**CONCEPTUAL MODEL EVALUATION (UPDATE)**

**Nevada Nuclear Waste Storage Investigation  
Subtask 1.4 Report #2**

**TECHNICAL ASSISTANCE IN HYDROGEOLOGY  
PROJECT B - ANALYSIS  
RS-NMS-85-009**

**OCTOBER 14, 1986**

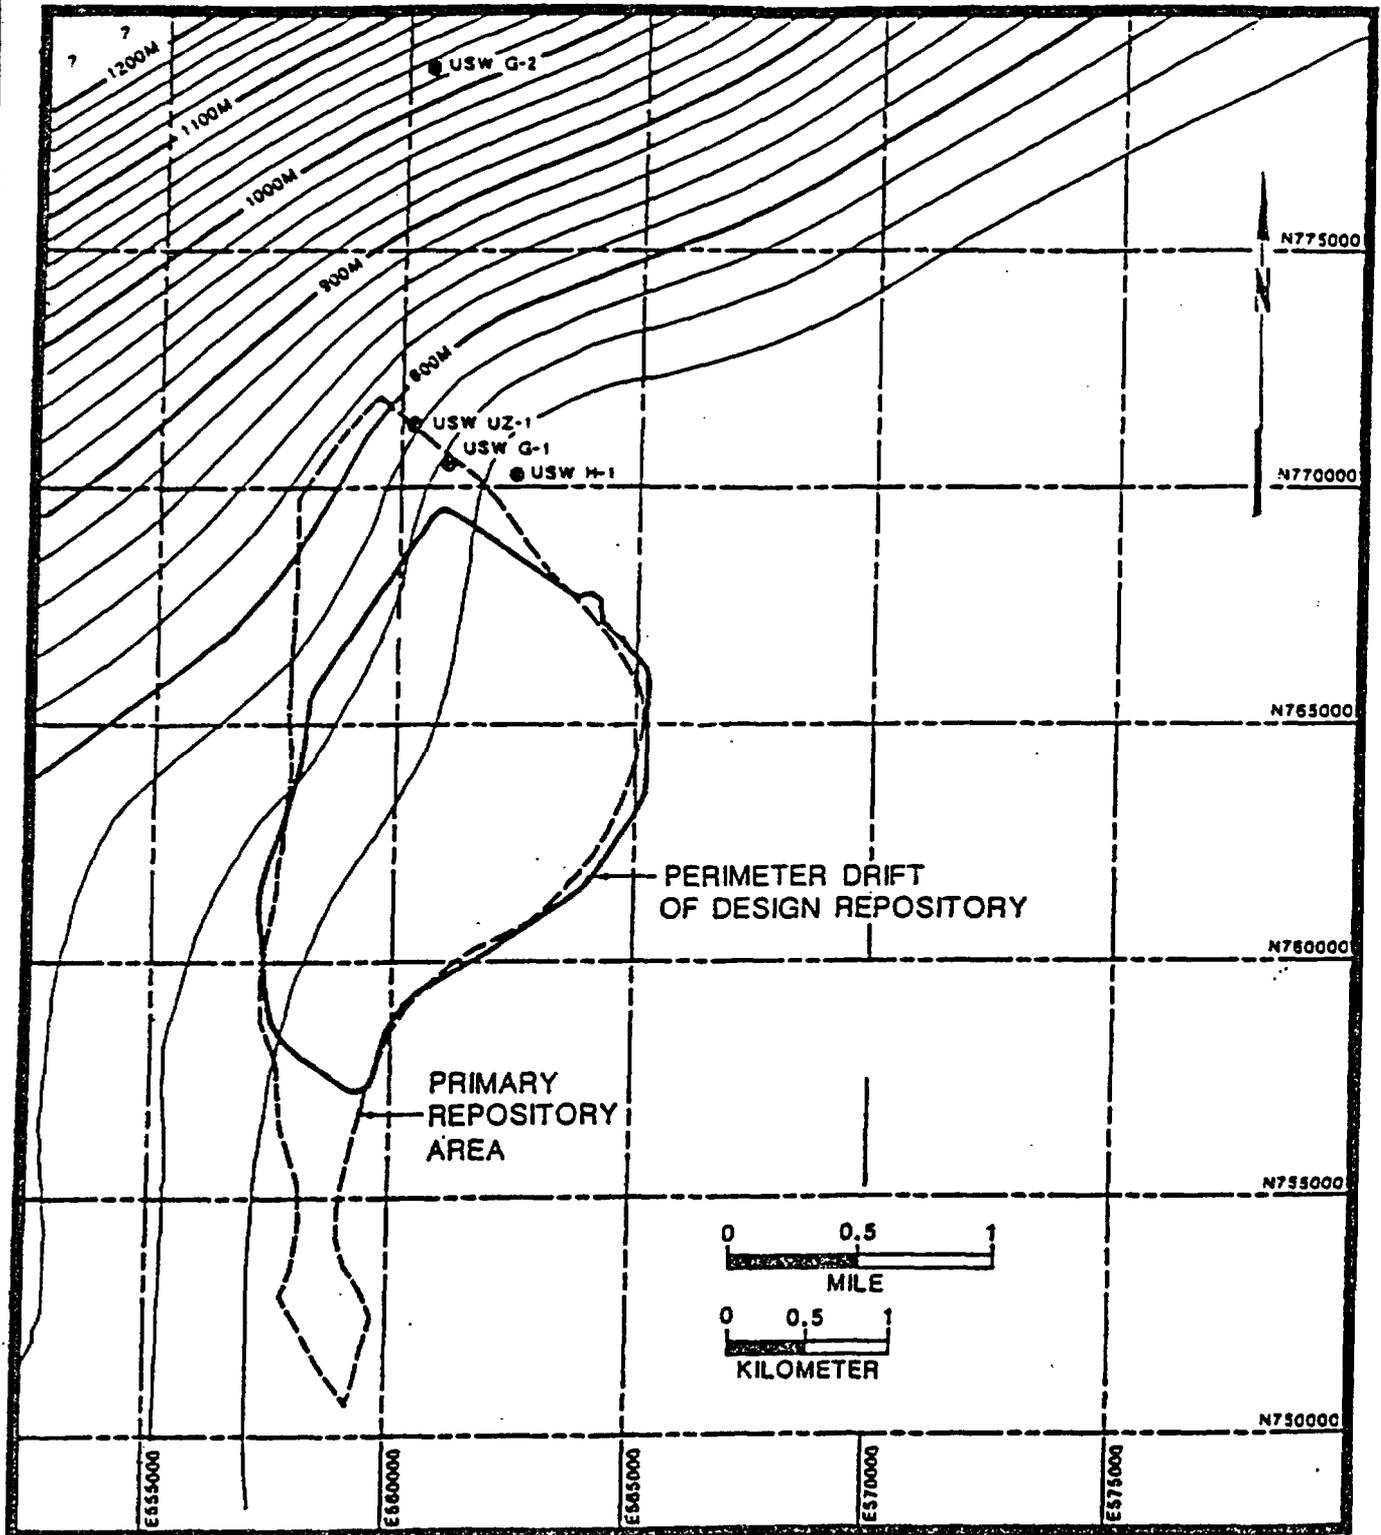
Several holes have been drilled in the vicinity of Yucca Mountain during the past several years. The holes which provide the information on which the following discussion is based are listed in Table 1 along with pertinent physical data for each of the wells. Approximate well locations relative to the primary repository block are shown on Figure 1 which also demonstrates the current DOE piezometric surface map.

# WATER LEVEL ELEVATION

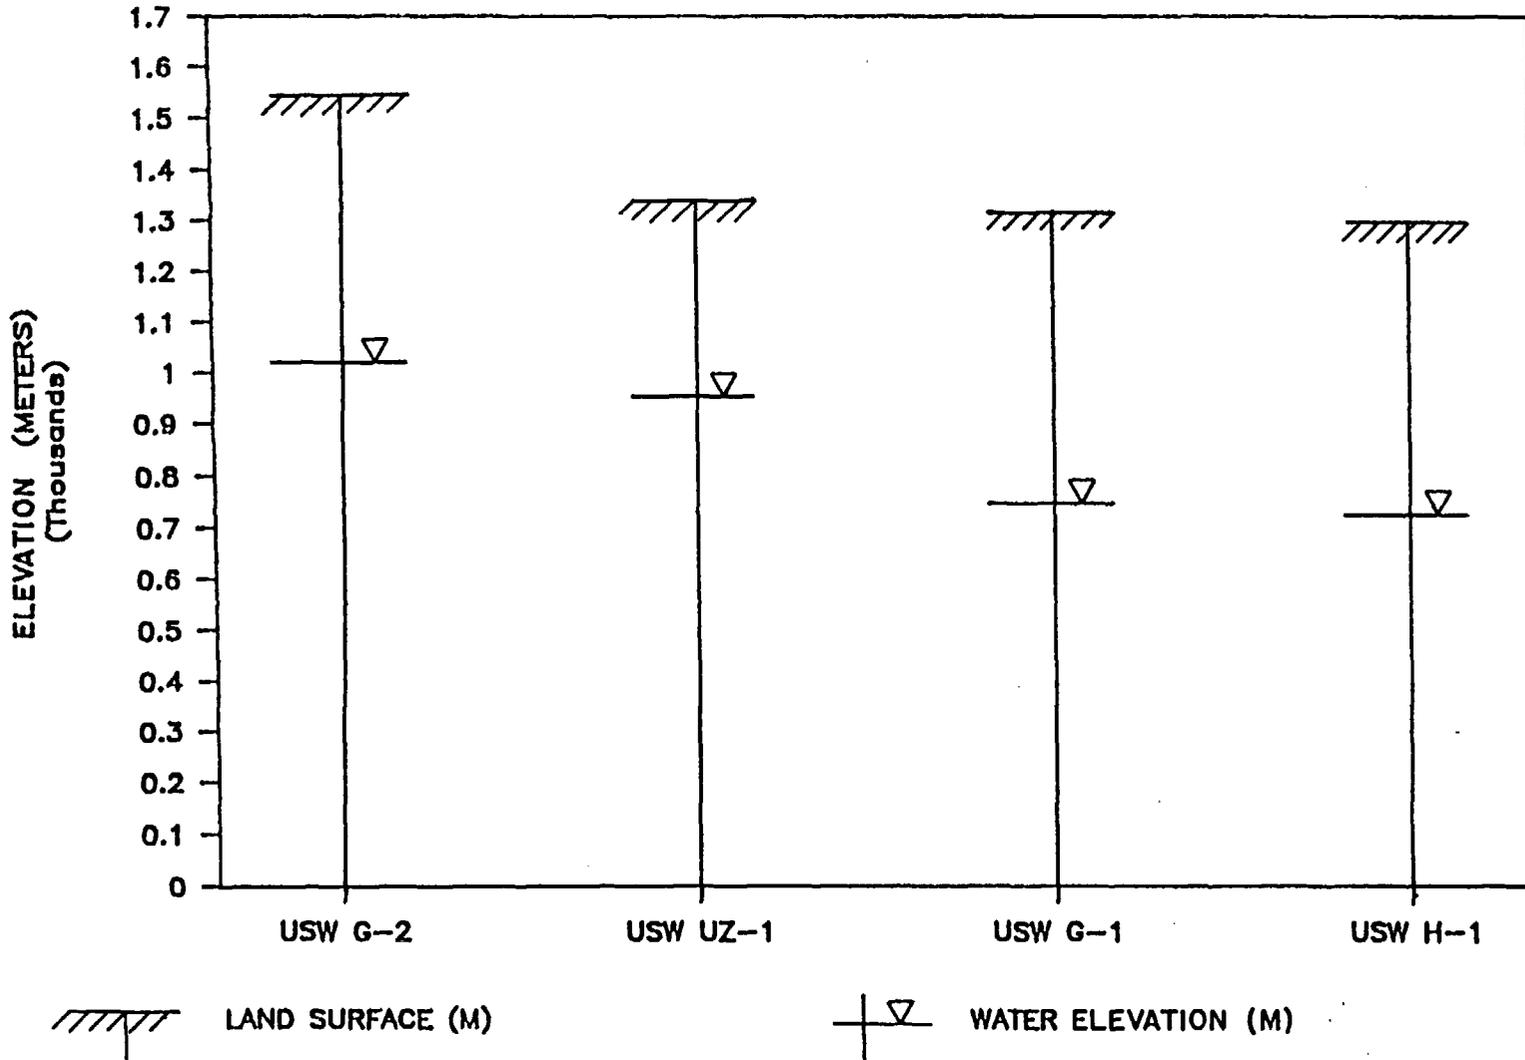
Encountering the water in USW UZ-1 at an elevation of 963 m which is significantly higher than the predicted elevation of about 780 and the determination that the water contained drilling fluid polymer from a well 305 meters away (USW G-1) raises serious questions about the fracture network in the Topopah Spring welded unit. First, fluid has moved laterally a significant distance, and secondly, the water has not rapidly "drained" through the unit. Since UZ-1 was completed in October, 1983, a period in excess of three years was available for the water from USW G-1 to drain from the fracture system. It has been postulated by the DOE that the drilling fluid "lost" during the drilling of borehole USW G-1 formed a perched water zone extending to borehole USW UZ-1.

If the water found in USW UZ-1 is indeed perched, then the Topopah Springs welded unit may not be as free draining as anticipated by the DOE. If the repository is placed in the Topopah Springs welded unit, the possibility of a saturated zone encompassing the waste at some point in the future may then exist. The saturated zone may be caused by increased infiltration due to a change in climatic conditions or due to a condensed layer of water formed by the heat load from the canisters. After condensing, the water could move downward and eventually pass through the repository layer.

If the water at USW UZ-1 is not perched, but is indeed the water table, then the water table altitude contours presented by the DOE in the EA would need to be radically changed. Based on the above discussion and information available thus far, the DOE has not proven conclusively that the water found at USW UZ-1 is perched. In the event that the water located in USW UZ-1 is the water table at that location, then it will probably be important to determine the reason for the large gradient which exists between the two wells, UZ-1 and G-1. Water levels (assuming the water in UZ-1 is the water table) along with surface elevations are depicted schematically on Figure 2 to demonstrate the change in gradient between the two wells.

Information obtained during the drilling of the USW UZ-1 well as to the amount of water pumped, drawdown during pumping (if any), and length of time the well was pumped before the decision was reached to cease drilling operations may give insights into the anomaly. This information may lead to the need to further characterize the Topopah Springs welded unit and the water table at the area near USW UZ-1.
